**DECLARATION OF WILLIAM HUGHEN IN
SUPPORT OF DEFENDANTS' MOTION FOR
SUMMARY JUDGMENT (Fed. R. Civ. P. 56)**

1 6. When I was a member of the Flex Team, I was assigned permit application related to a
2 project at 200 Naples St. in San Francisco. The permit application was identified as PA
3 202108096049. I was assigned this project by my then supervisor, Natalia Fossi (formerly
4 Kwiatkowska), on August 26, 2021.

Exhibit A

PAT GALLAGHER
NEW ADU
200 NAPLES ST. SAN FRANCISCO CA 94112
PH: 925-325-3911

NEW ADU - SITE PLAN,
BUILDING DATA, SHEET INDEX,

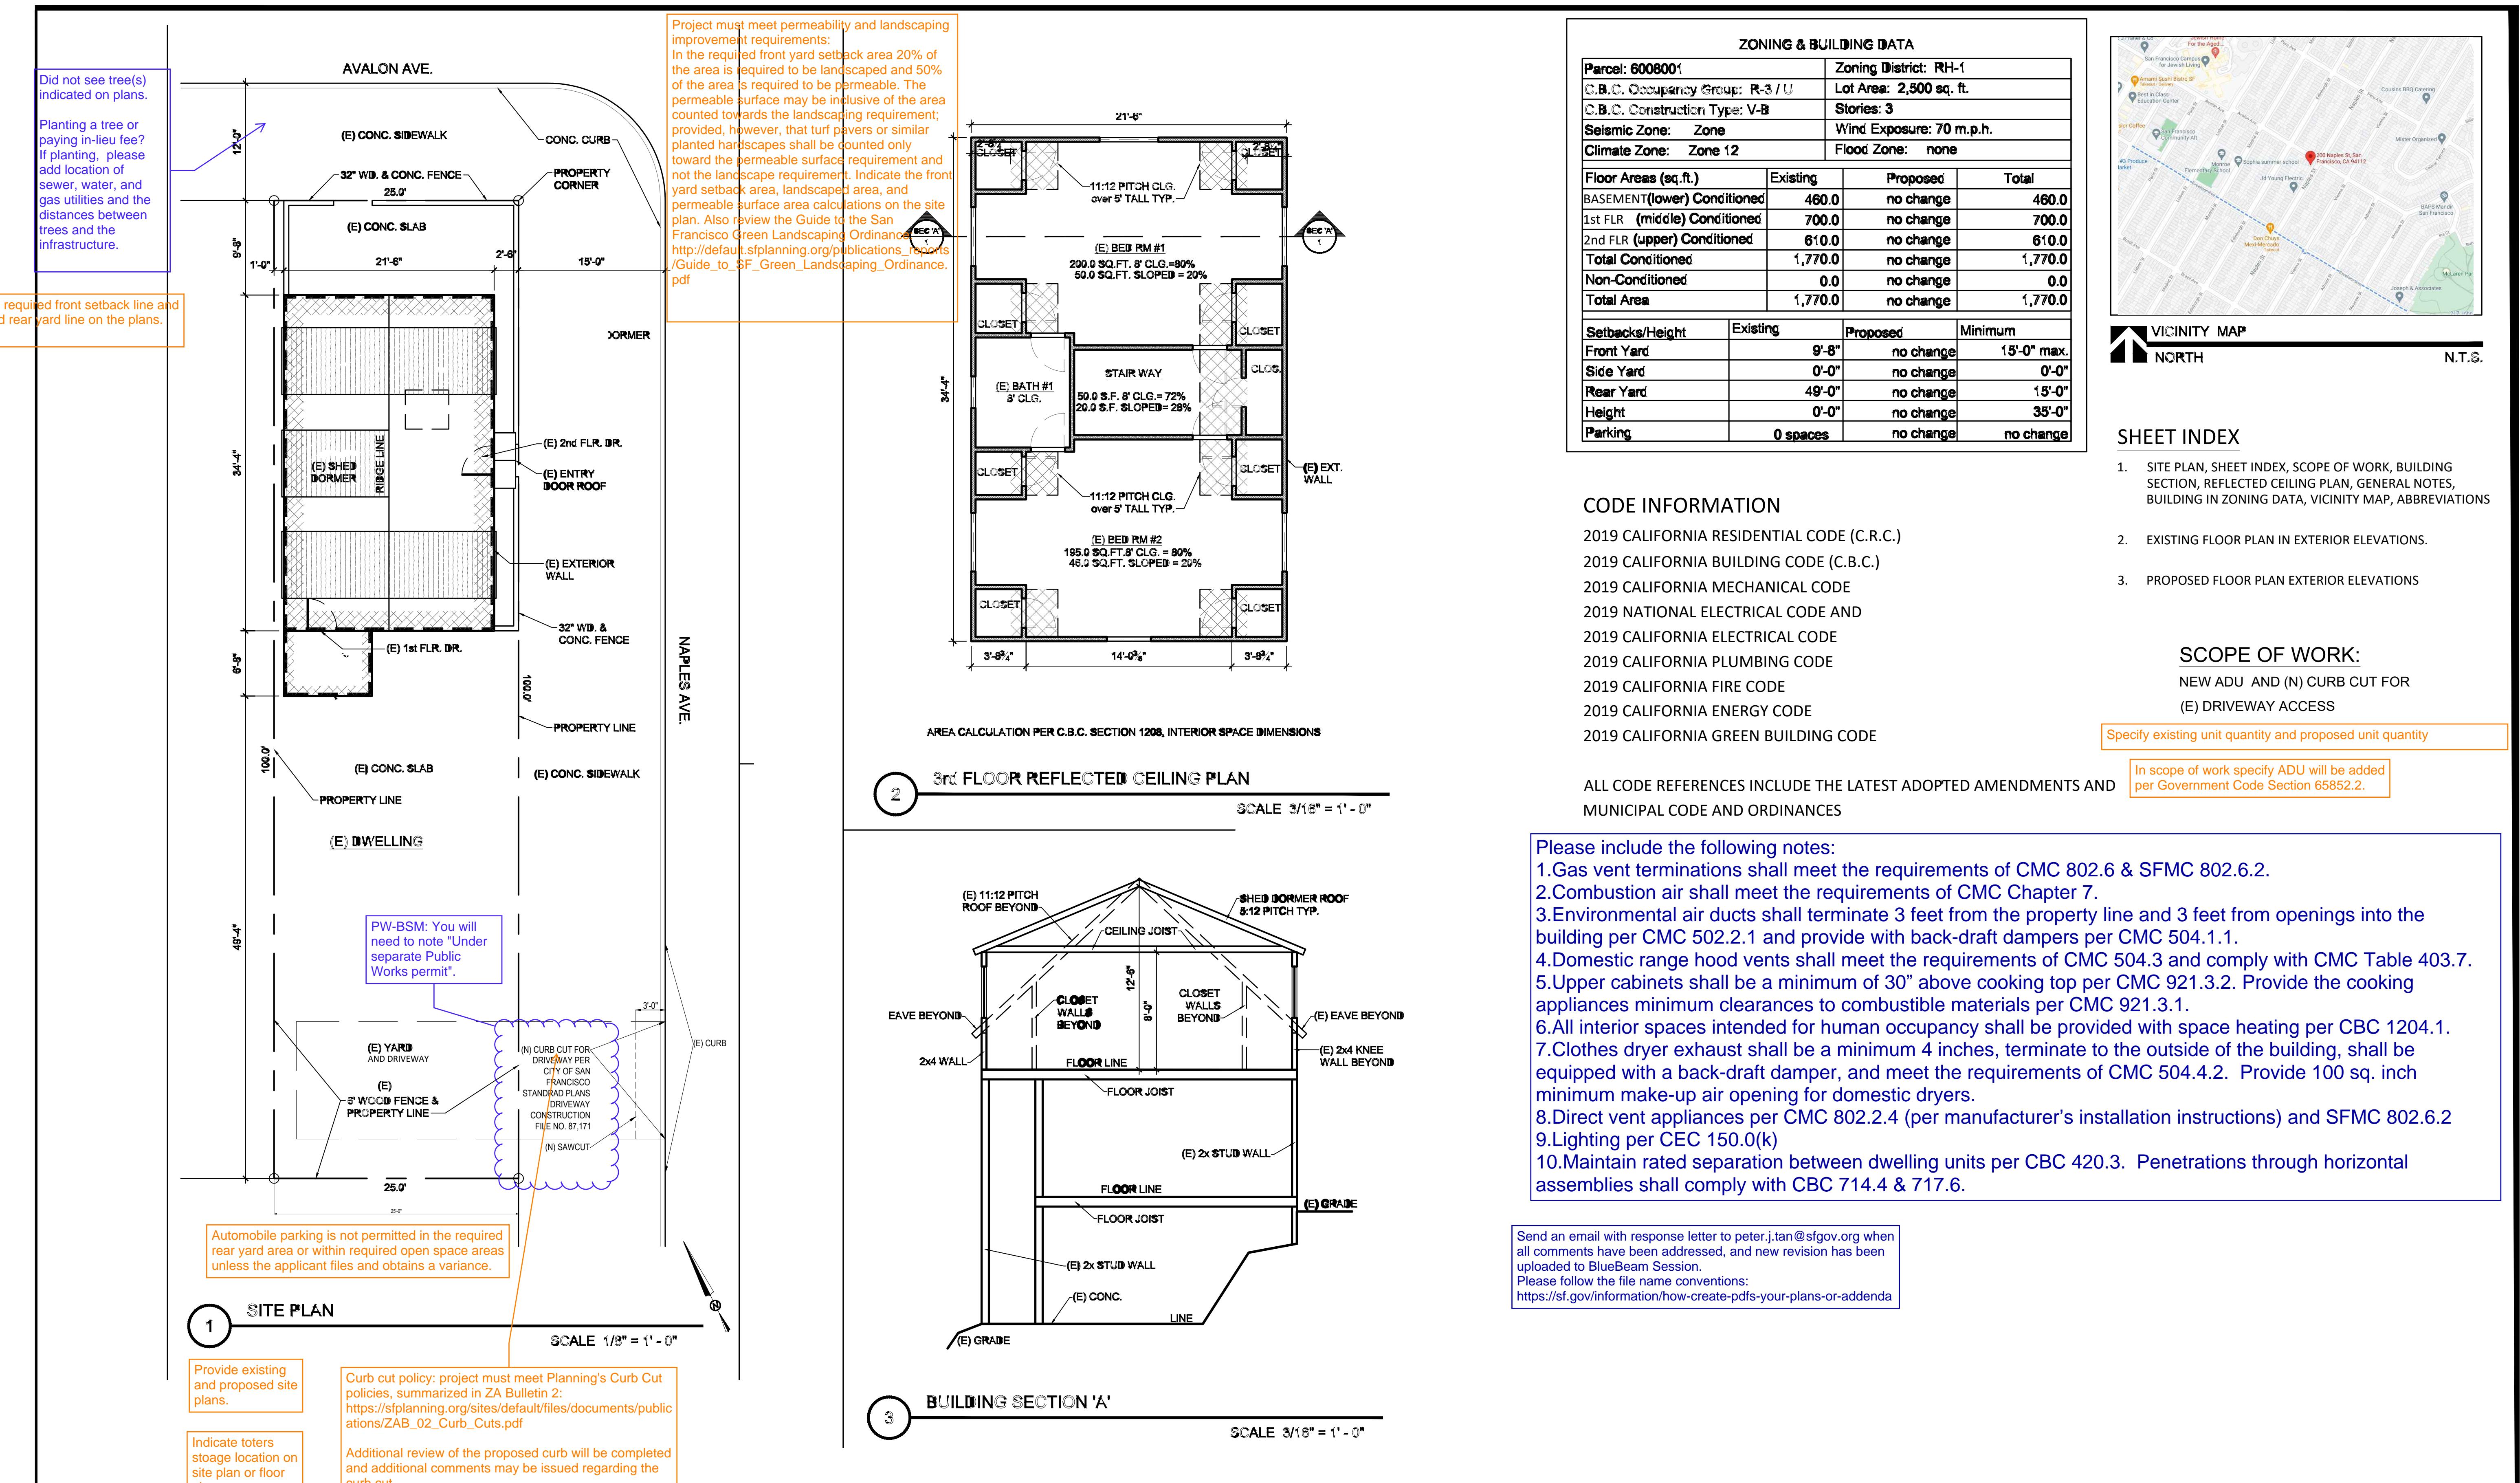
- 20 (a) “Specify required front setback line and required rear yard line on the plans,”
- 21 (b) “Project must meet permeability and landscaping improvement requirements: In the
22 required front yard setback area 20% of the area is required to be landscaped and 50% of the
23 area is required to be permeable. The permeable surface may be inclusive of the area counted
24 towards the landscaping requirement; provided, however, that turf pavers or similar planted
25 hardscapes shall be counted only toward the permeable surface requirement and not the
26 landscape requirement. Indicate the front yard setback area, landscaped area, and permeable
27 surface area calculations on the site plan. Also review the Guide to the San Francisco Green
28 Landscaping Ordinance:

3 (c) “Specify required front setback line and required rear yard line on the plans”,

4 (d) “In scope of work specify ADU will be added per Government Code Section
5 65852.2,”

6 (e) “Automobile parking is not permitted in the required rear yard area or within
7 required open space areas unless the applicant files and obtains a variance,”

8 (f) “Curb cut policy: project must meet Planning's Curb Cut policies, summarized in
9 ZA Bulletin 2:

13 (g) “Provide ADU square footage (just the unit) on the floor plan,” 8) “Clarify
14 excavation quantities and specify on the planset. If no excavation is proposed specify this on
15 the planset,”

19 (i) “Clarify window location of ADU that faces Avalon Blvd. This is shown in different
20 locations in the floor plan and elevation,”

23 (k) “This appears to not be a solid wall based on streetview. Please clarify and show as
24 it exists (with gates, if existing).”

EXISTING 1st FLOOR PLAN (LOWER)

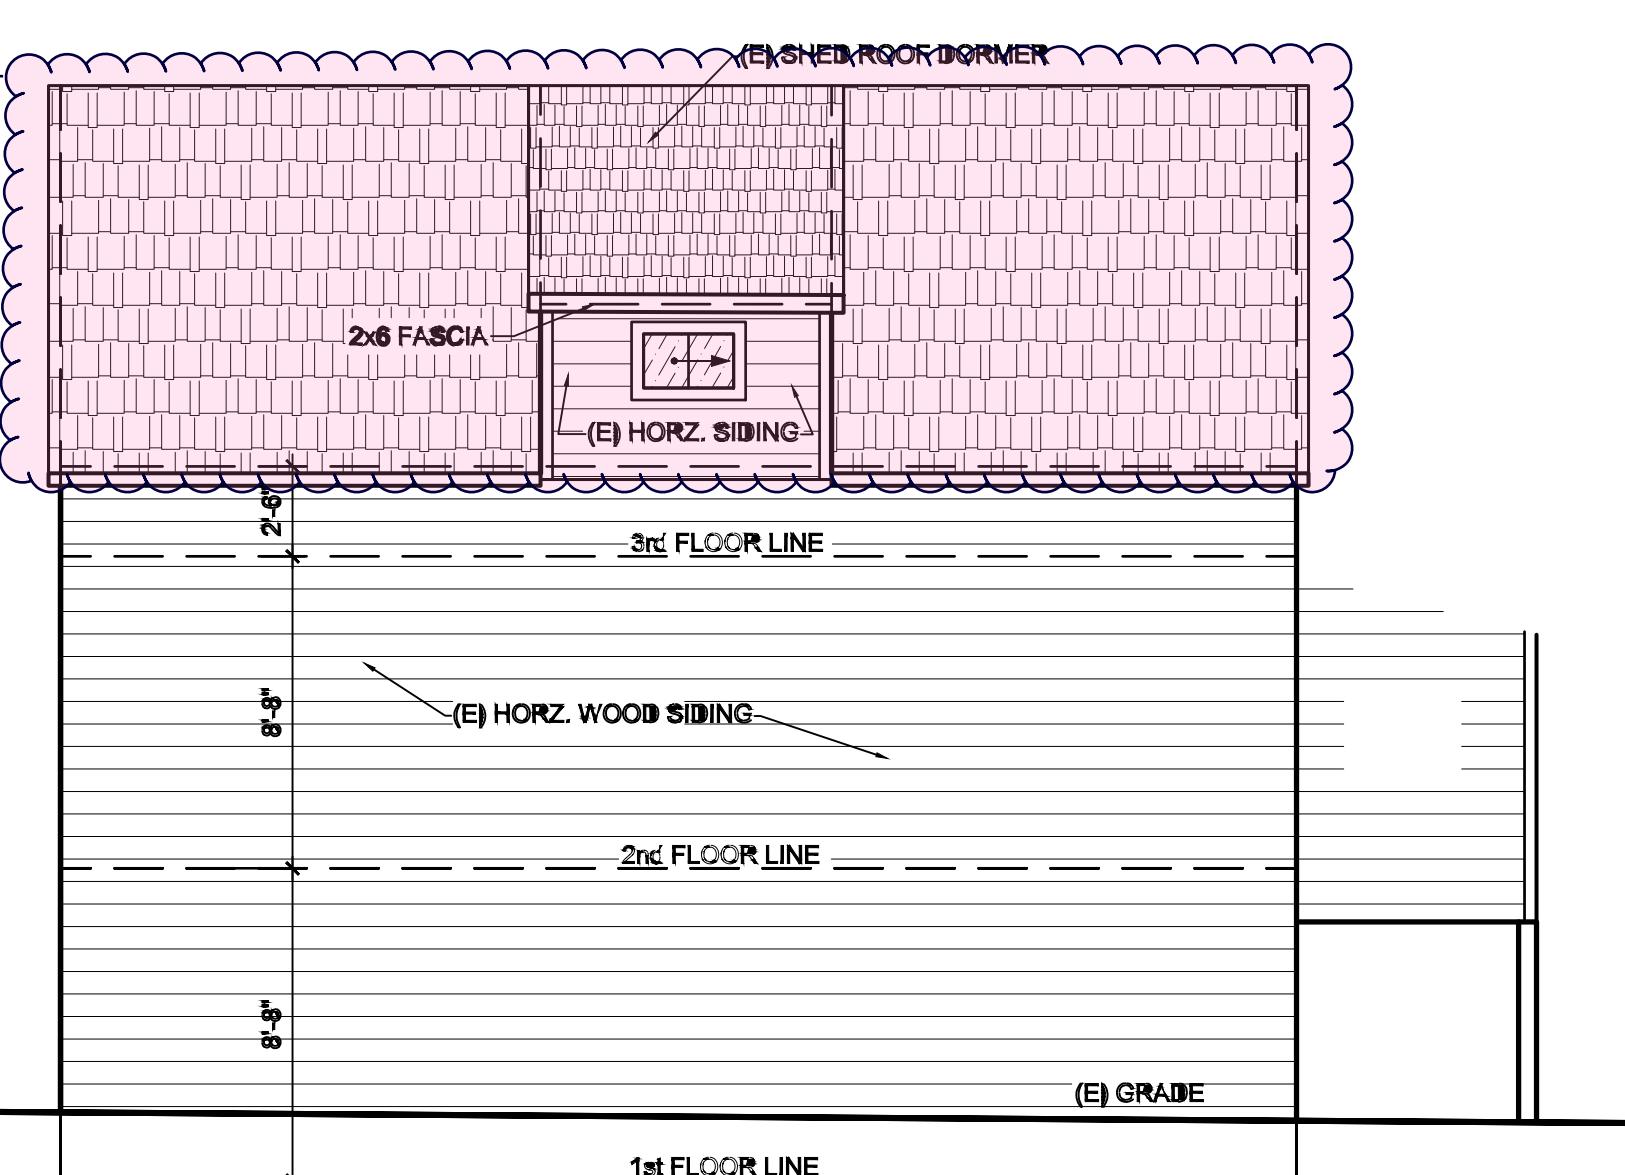
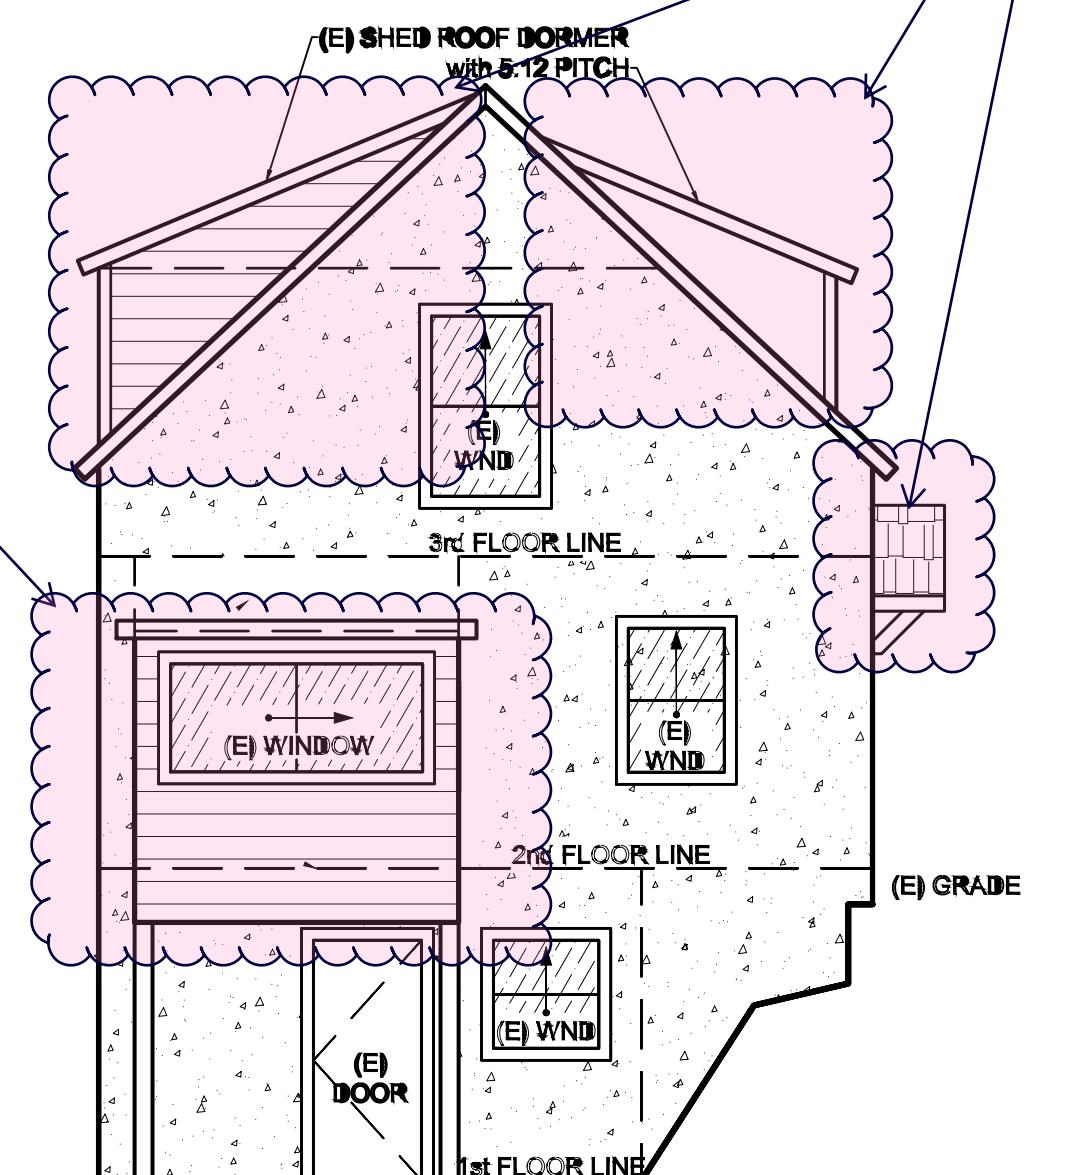
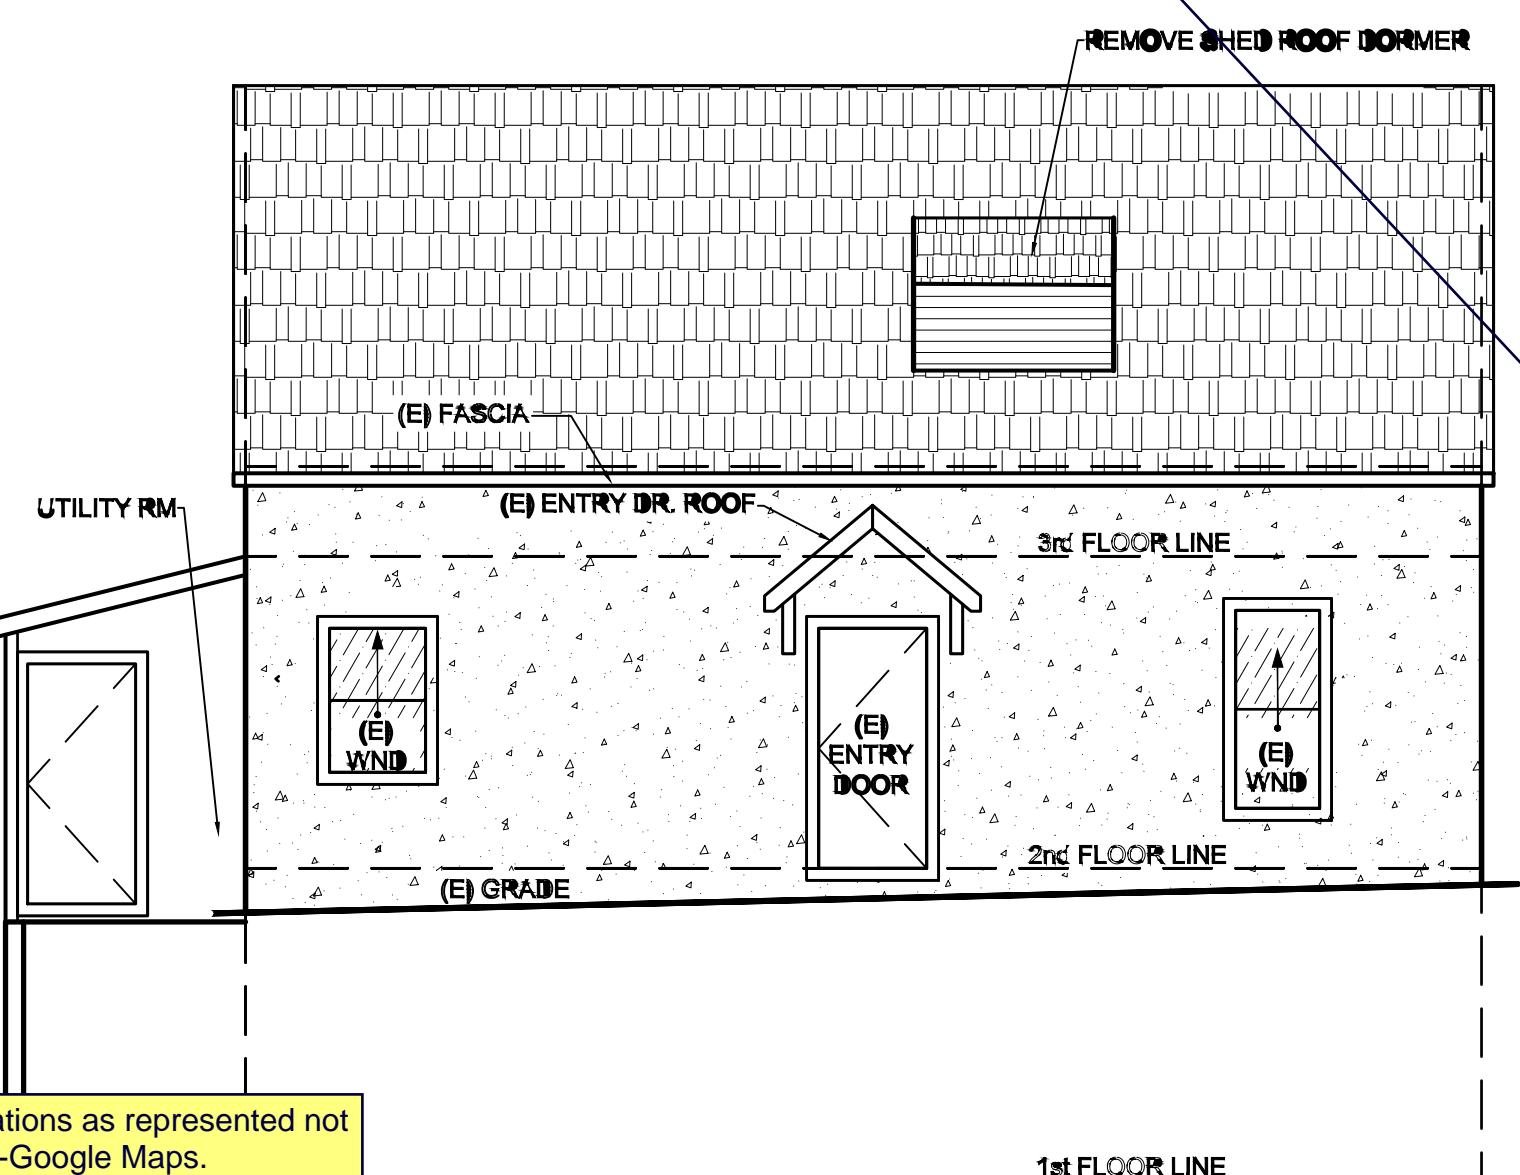
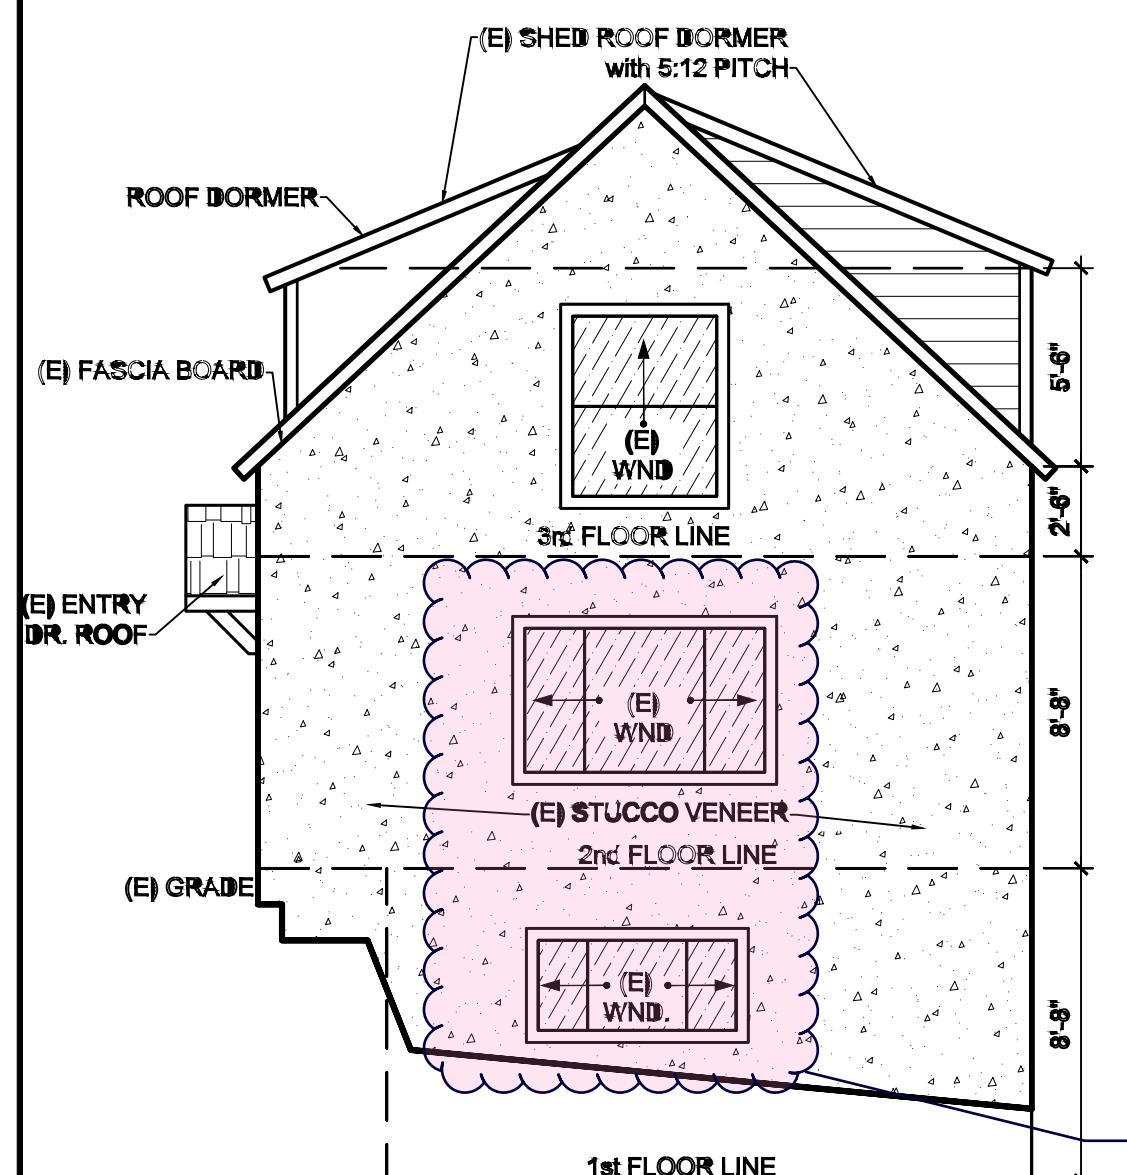
16 (h) “Provide common laundry facilities or provide private laundry facilities for each
17 unit. Laundry must be in a location that can be accessed by both units if proposing common
18 laundry”,

21 (j) “Specify new path of travel for main existing unit's access to rear yard open space
22 area,” and
